TENNESSEE VALLEY AUTHORITY

This letter is in response to your letter to TVA dated May 16, 1985 requesting numerous documents related to our Watts Bar Nuclear Plant. With the exception of your item 23 (83-10-31-L), all documents requested are enclosed. Please note that your item 24 duplicates item 4 and item 22 duplicates item 19.

LIST OF DOCUMENTS ON WATTS BAR CONCERNS

WATTS BAR NUCLEAR PLANT  
INDEPENDENT REVIEW

Figure 1

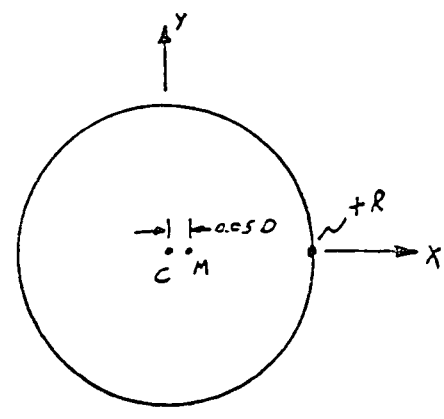
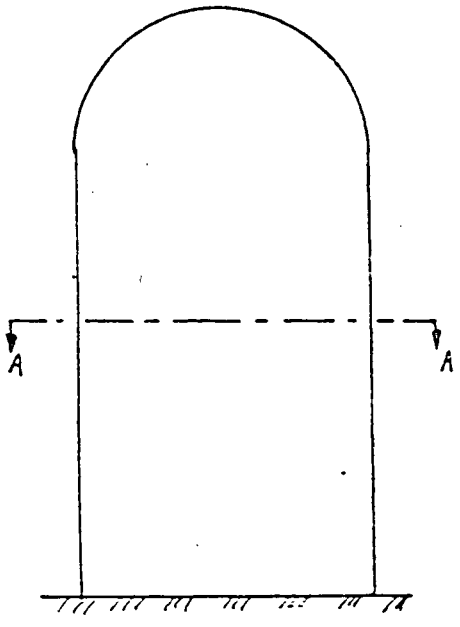
Agree that this finding identifies a failure to meet a direct FSAR commitment.

Bellefonte containment analyses used 5% eccentricity. Review of the Bellefonte analyses has shown the effect of not using 5% eccentricity on Watts Bar to be small. The attached provides additional information on why the effect is small.

Consider a cylindrical containment vessel with a spherical dome, as shown in figure 1. It is nominally symmetric about its central vertical axis. To meet the commitment, the analyst would assume an arbitrary offset (equal to 1/20th of the diameter of the structure) of the center of mass, M, from the center of the structure, C. Since the mass is then eccentric to the center of twisting (known as the shear center), base ground motion (such as an earthquake) along the + and - y axes in figure 1 will induce both lateral shear forces and torsion in the structure. The eccentric mass will also result in the formation of vibration modes involving simultaneous (or coupled) translational and rotational motion.

Rather than apply the arbitrary 5-percent eccentricity, the analyst calculated actual eccentricities at various levels of the structure. The most significant of these were due to hatches, although, at most, the eccentricities are equal to approximately 1 percent of the diameter. Thus, part 2 of the intent of the commitment was met. TVA has considerable data supplied by the designer and constructor of the vessel (Chicago Bridge and Iron Company) to show that the structure has insignificant additional eccentricity due to construction tolerances.

1. The FSAR commitment was not met.
2. The original intent of the FSAR commitment was met.
3. The effect of not meeting the FSAR commitment is minimal.

Figure 2.

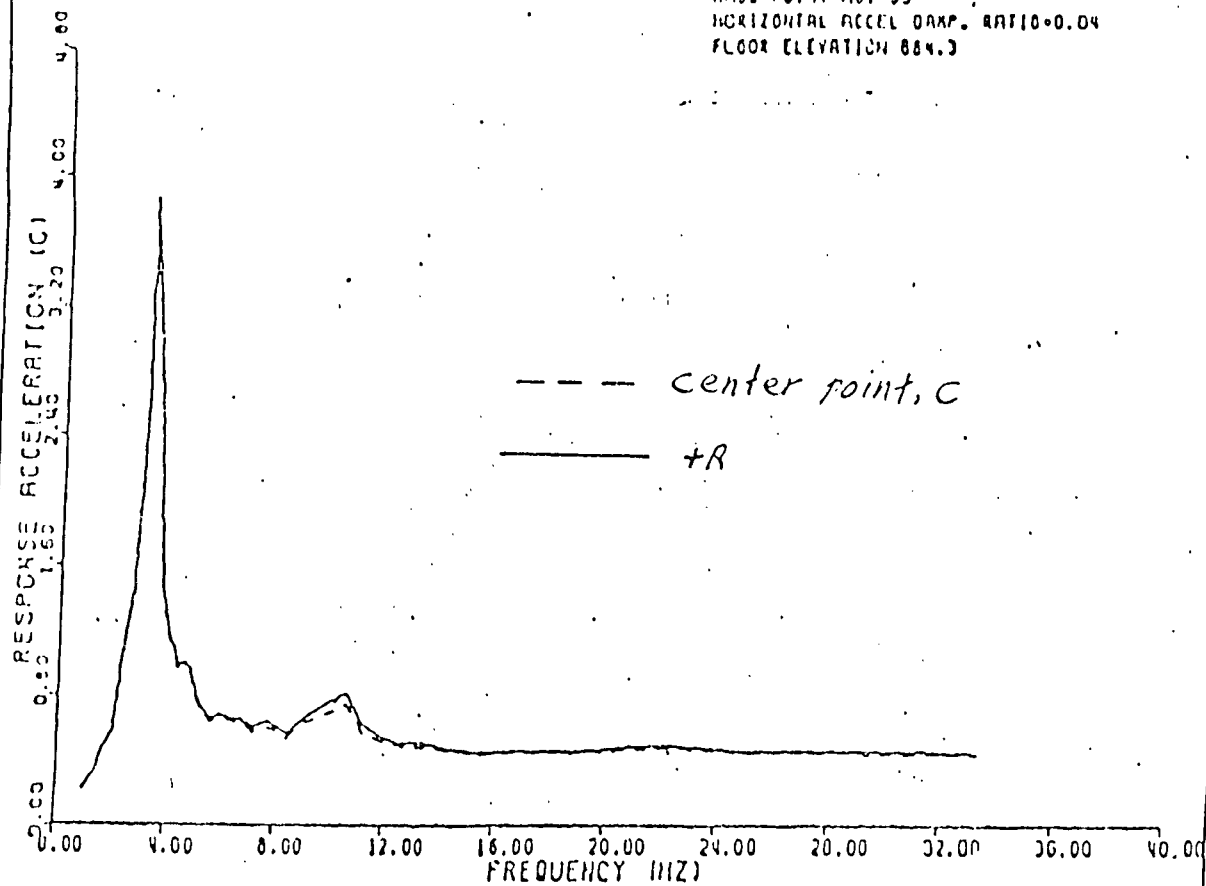
In those instances where TVA has used 5-percent eccentricity on cylindrical structures, the effect has been shown to be small. One way of expressing the effect of including the 5-percent eccentricity is to compare the motion of a point on the shell (shown as "+R" in section A-A, figure 1) to the motion of the center of the cylinder, C. If the torsional effects are significant, the motion of these two points will be significantly different. Figure 2 is a response spectrum plot of these two points for the seismic

analysis of the Bellefonte Nuclear Plant secondary containment structure. (It is a plot of the peak acceleration of subsystems of various frequencies attached to the structure.) Since the two points have almost identical response spectra, the effect of considering the 5-percent eccentricity is seen to be small.

This effect should be even less for the Watts Bar Nuclear Plant containment vessel, since its first torsional vibration mode is at approximately 15 hertz (cycles per second), compared to the 10 hertz coupled torsional-translational mode for the Bellefonte secondary containment and since there is considerably less seismic ground motion input at 15 hertz than at 10 hertz.

FINDING # F710

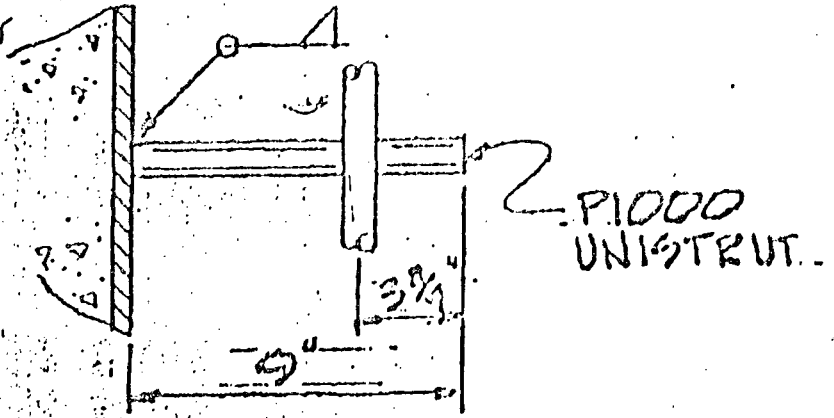
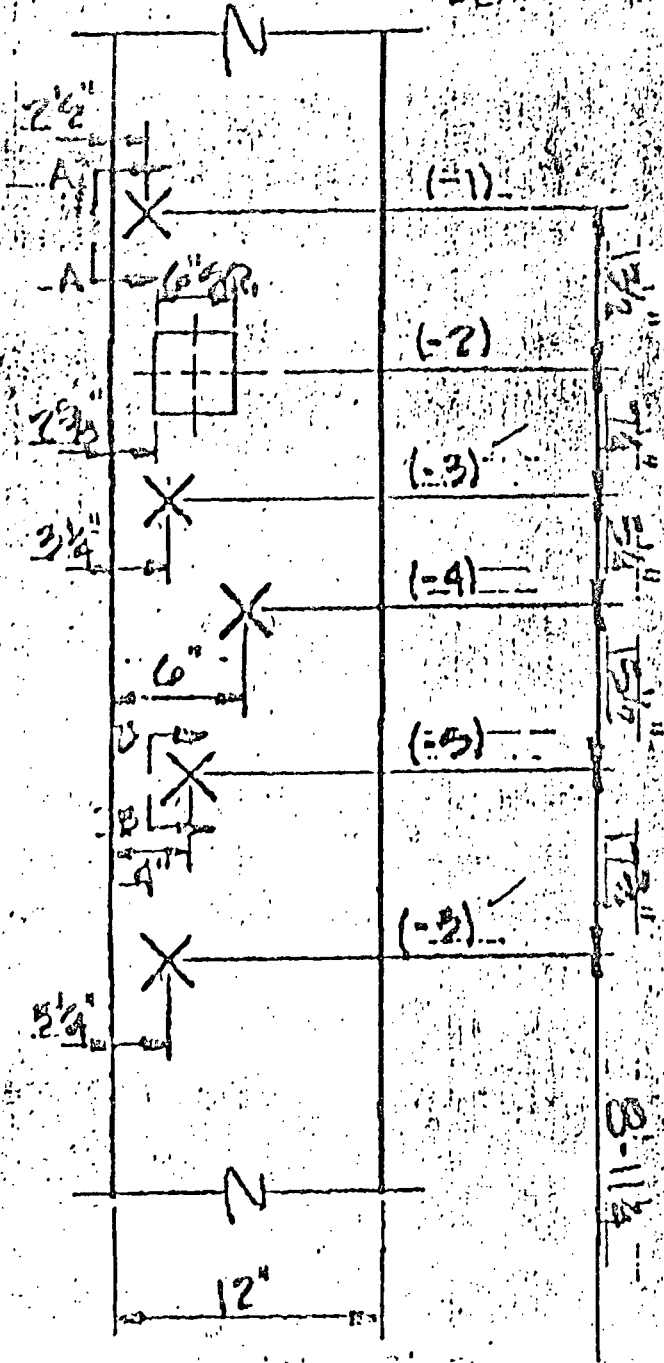
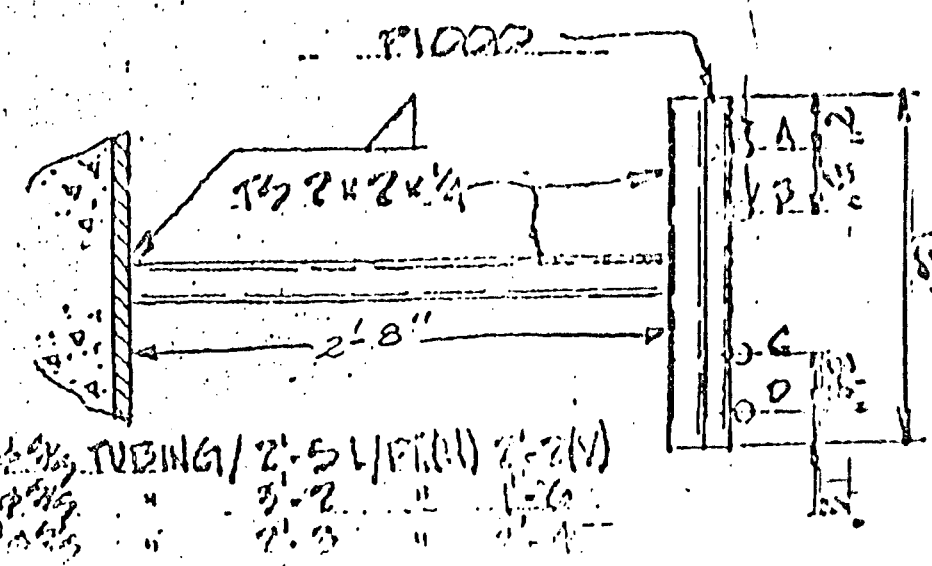
Attached are the design calculations for the embedded plate MK 40W. These calculations confirm adequacy of the embedded plate. These calculations would have been performed later if necessary to address NCR WBNCB 8203, issued March 1982, but were accelerated to address this finding. The calculations are adequate to close the NCR in so far as the embedded plate is concerned; however, NCR WBNCB 8203 must remain open because it is generic to a large number of embedded plates and thus closure of NCR WBNCB 8203 should be added to your punch list.

Please recycle on level 2 if the attached calculations are not sufficient hard evidence to show the plates in question are acceptable.

$$\frac{0.878^K}{10.2^K} + \frac{10.49^{K \cdot IN}}{67.00^{K \cdot IN}} = 0.27 < 1.0$$

ASSUMING ALL LOADS ACTS AT SAME PT.  
VERY CONSERVATIVE

FIGURE 1

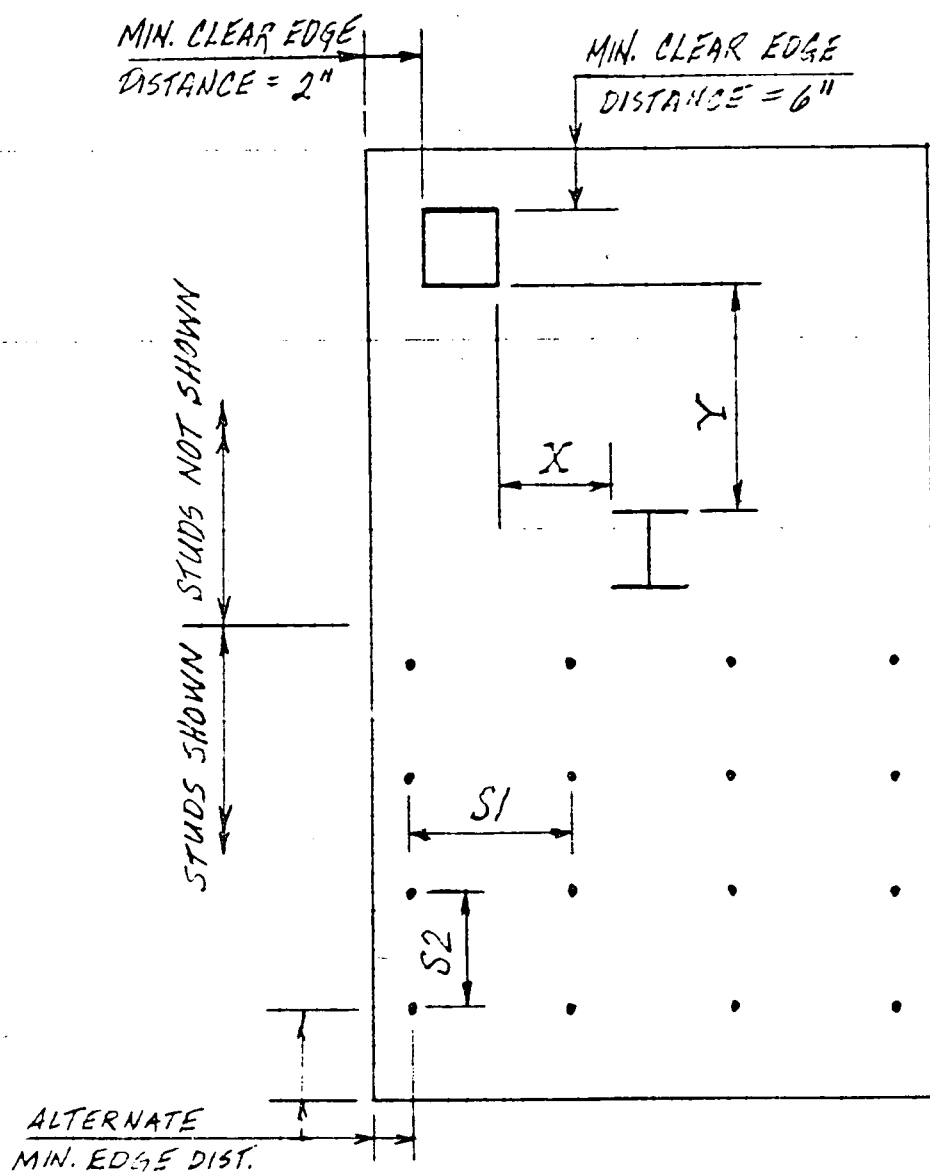
In general, the minimum clear distance between an attachment and the long edge of a rectangular plate or the edge of a square plate shall be 2 inches. The minimum clear distance between an attachment and the short edge of a rectangular plate shall be 6 inches. For a specific plate, the minimum clear distance may be reduced to the distance from the plate edge to the centerline of the row of studs parallel to the edge (see figure 1).

In general, the clear distance between attachments to embedded plates shall be determined from two measurements. Each measurement shall be taken parallel to a plate edge as shown in figure 1.

The minimum clear distance in at least one direction parallel to a plate edge shall be 24 inches. For a specific plate, the minimum clear distance may be reduced to two times the spacing of the stud rows which are perpendicular to the direction of measurement (see figure 1).
